FISH PASSAGE CENTER

MEMORANDUM

RE: Additional irrigation withdrawals from the upstream portion of the John Day Reservoir of the Columbia River

FIGURE 18.--Maximum and minimum daily discharges of Alder Creek at Alderdale and Rock Creek near Roosevelt, 1963-68. From Brown (1979).

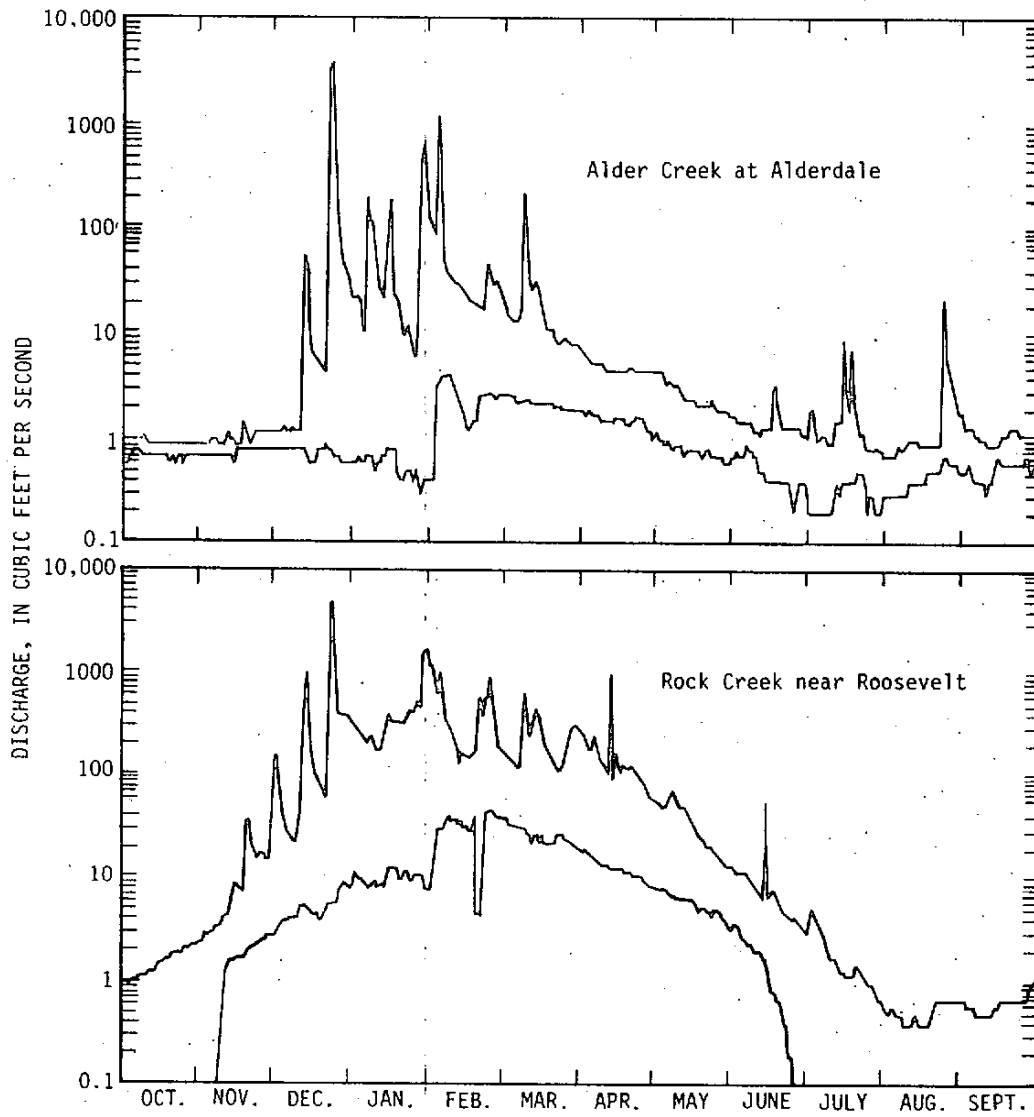
- Assuming that Rock Creek is the location and source of mitigation water, there is a lack of current stream flow record for Rock Creek which is known to be an ephemeral stream. The only record of flows that have been obtained occurred in the 1960's, during which period the minimum flow record shows Rock Creek to be dry over the months of July, August, and September. The maximum flow record for the same months shows a lesser discharge than needed to sustain an even release of the 4000 acre-ft. over the entire period from June through September. The source of the proposed mitigation water volume should be reviewed.

Rock Creek is located within Water Resource Inventory Area (WRIA) 31 which includes four subbasins: Rock Creek, Wood/Alder Creeks, Glade/Fourmile Creeks, and Kennewick. There is limited stream flow data available for WRIA 31, only two flow gages in WRIA 31 (Rock and Alder Creeks) have had continuous flow data, and the data were recorded over the years 1963–1968 (Molenaar, 1982). According to reports, the 1960s gauging period occurred within a cool/wet climatic cycle; therefore the streamflow record from these gauges may overestimate long-term average conditions (Aspect Consulting, 2004). The flow records from both Rock and Alder Creeks were plotted in the 1982 report by Molenaar produced in cooperation with the USGS. These plots are shown below, shown exactly as produced in the report. Despite, the possible overestimation of this period in terms of stream flow, the obtained 1960s minimum flow record shows Rock Creek to be dry over the months of July, August, and September. The maximum flow record for the same months shows a lesser discharge than needed to sustain an even release of the 4000 acre-ft. over the entire period from June through September (16.5 cfs per day). In summary, the available flow record shows Rock Creek to be seasonally dry, or ephemeral. Furthermore, according to the available record, even under maximum flow conditions over the June–September period, flows are not sufficient to support the needed 16.5 cfs over a 4-month period to provide the 4000 acre-ft. From the available flow record, it does not appear that Rock Creek is capable of providing 4000 acre-ft. (16.5 cfs/d) of flow input into the Columbia River over the months between June and September, even under maximum flow conditions.
